TGn Sync Response to Questions

Date: **2005-03-16**

Benefits of TGn Sync Extended MCS set (from presentation)

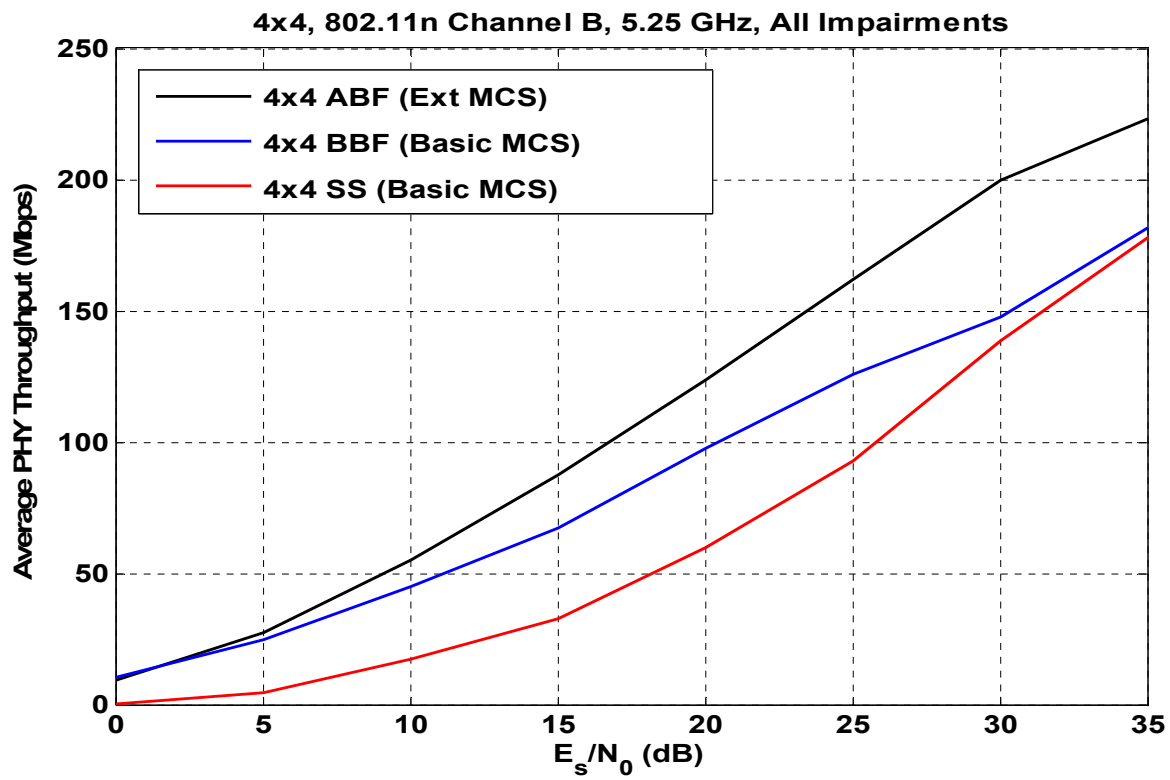
In ABF, instead of having, for example, {256-QAM, 256-QAM, 256-QAM, QPSK}, why not just use 3 spatial streams if the streams are that different in quality?

Tx BF is superior to STBC

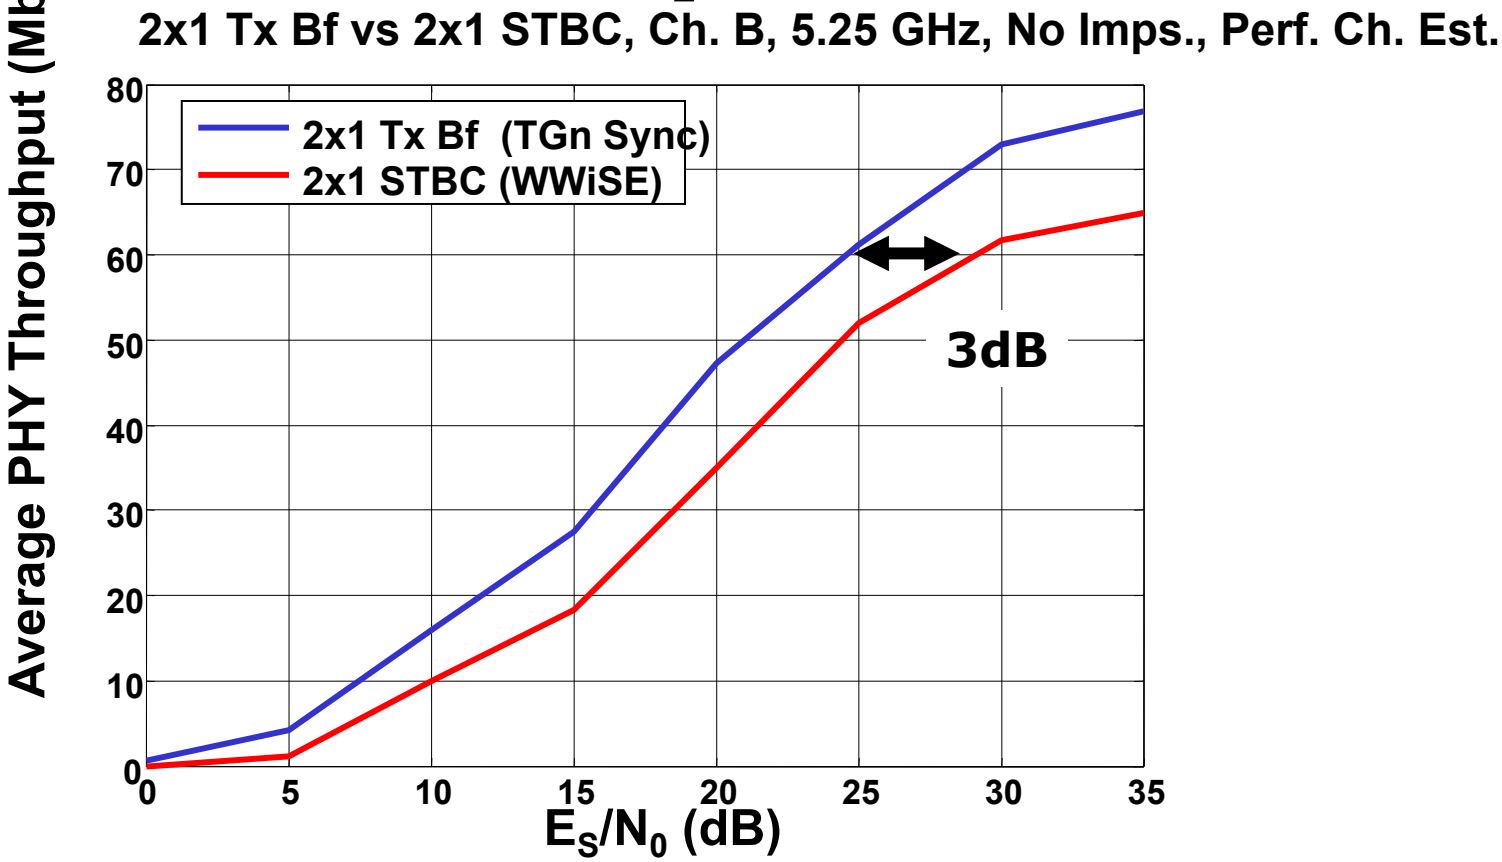
Why are space-time block codes missing from the proposal?

- Is there any technical reason why these have been omitted?

- Simplicity, not needed since TxBf outperforms it. Additional complexity of 2-symbol processing, overhead ofextra dead symbol etc.

➡ Also complexity of dual symbol processing, more modes etc.
